# UNITED STATES PATENT AND TRADEMARK OFFICE

10/575,191

<b>Office Action Summary</b>	<b>Application No.</b> 10/575,191	<b>Applicant(s)</b> WADA, SHIZUO	
	<b>Examiner</b> Fannie Kee	<b>Art Unit</b> 3679

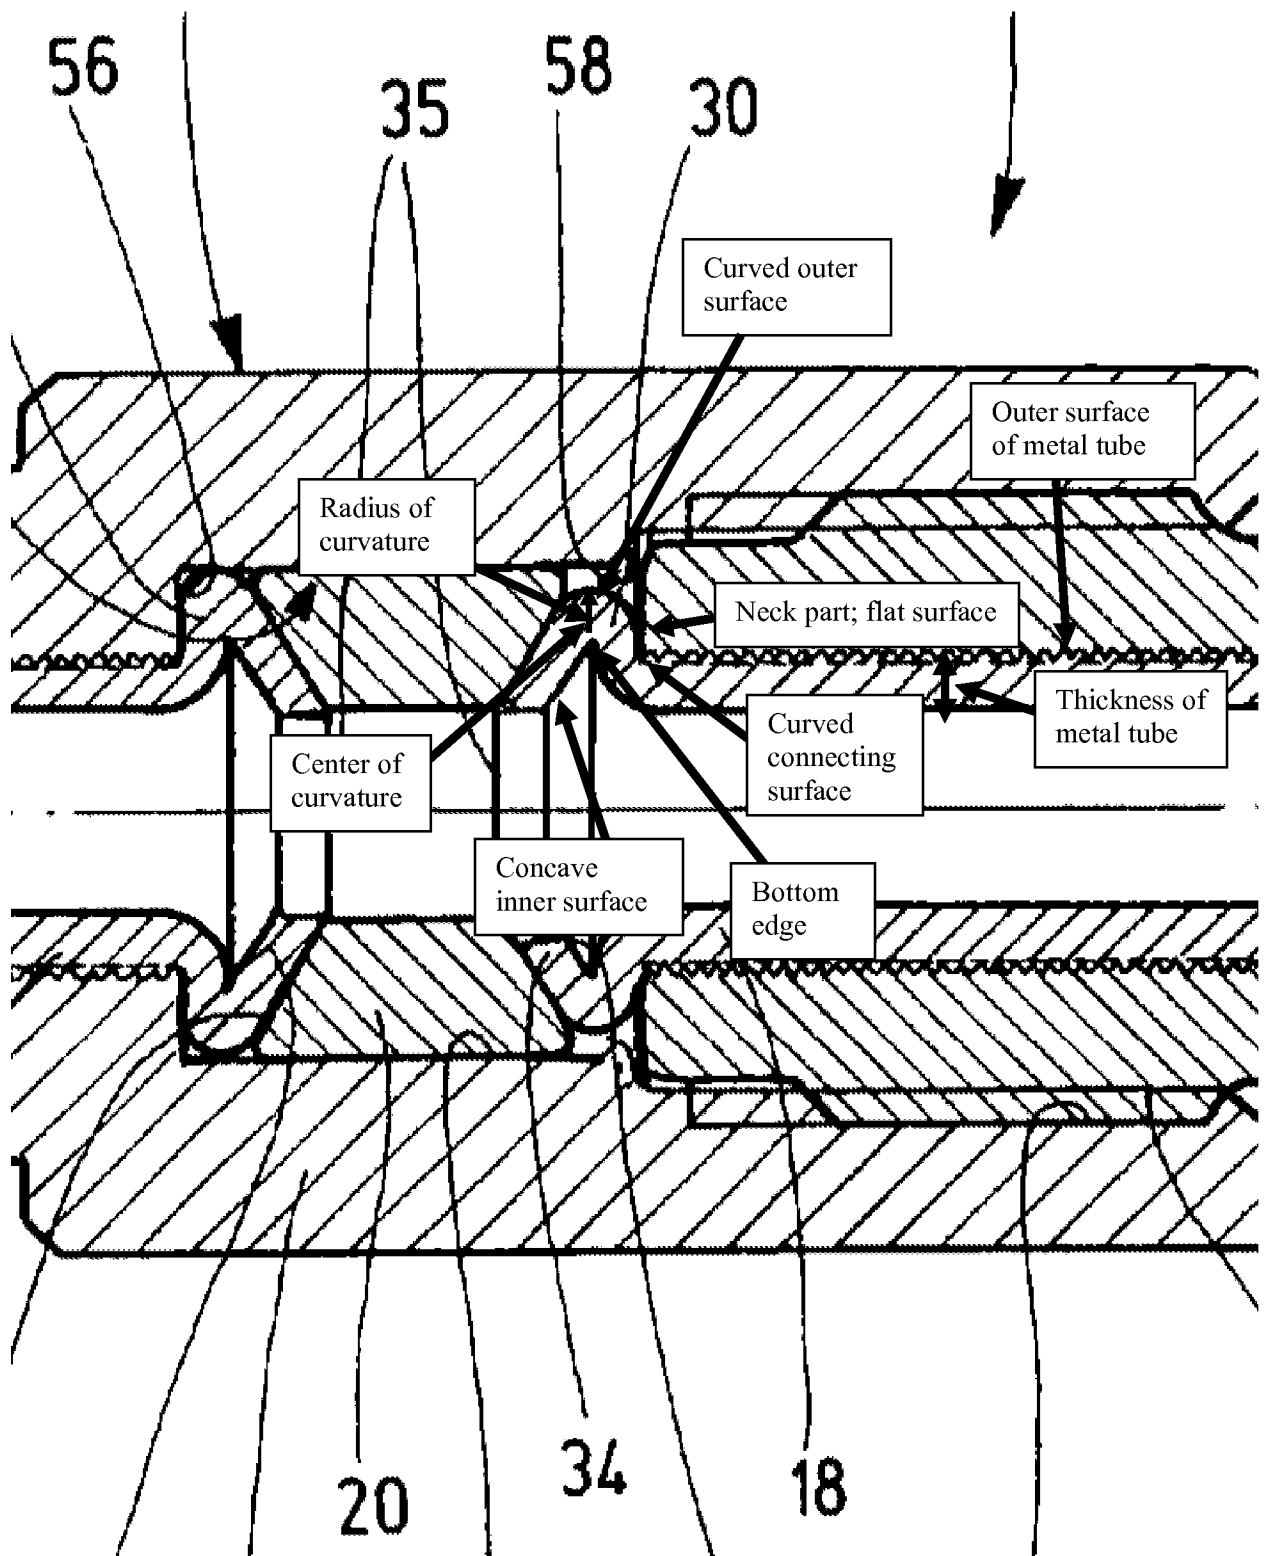
With regard to claim 1, and as seen in the figure below, Stahn et al disclose a flared end structure of a metal tube to be pressed against a seat formed in a member by tightening a coupling nut to the member, said flared end structure having a joining end part **(34)** to be pressed against the seat of the member, and a curved part **(30)** continuous with the joining end part;

wherein the curved part **(30)** has a curved outer surface with respect to the axis of the tube and a concave inner surface having a bottom edge, and

the curved outer surface has a radius R of curvature smaller than a wall thickness t of the metal tube so as to increase the rigidity of the flared end structure.

With regard to claim 2, and as shown in the figure above, Stahn et al disclose a flared end structure of a metal tube to be pressed against a seat formed in a member by tightening a coupling nut to the member having a joining end part **(34)** to be pressed against the seat of the member, and a curved part **(30)** continuous with the joining end part;

wherein the curved part **(30)** has a curved outer surface with respect to the axis of the tube and a concave inner surface having a bottom edge, and

the curved outer surface has a center of curvature at a position on the radially outer side of the bottom edge of the concave inner surface with respect to the axis of the tube so as to increase a rigidity of the flared end structure.

With regard to claim 3, and as shown in the figure above, Stahn et al disclose the curved outer surface merging into a flat surface, on which a coupling nut exerts pressure, of a neck part, and the bottom edge of the concave inner surface is in a radial range corresponding to the flat surface of the neck part.

With regard to claim 4, and as shown in the figure above, Stahn et al disclose the flat surface of the neck part being perpendicular to the axis of the tube.

With regard to claim 5, and as shown in the figure above, Stahn et al disclose the flat surface of the neck part being connected to the outer surface of the metal tube by a curved connecting surface having a center of curvature at a position radially outside the metal tube, and

the flat surface extends between the curved outer surface of the curved part and the curved connecting surface.
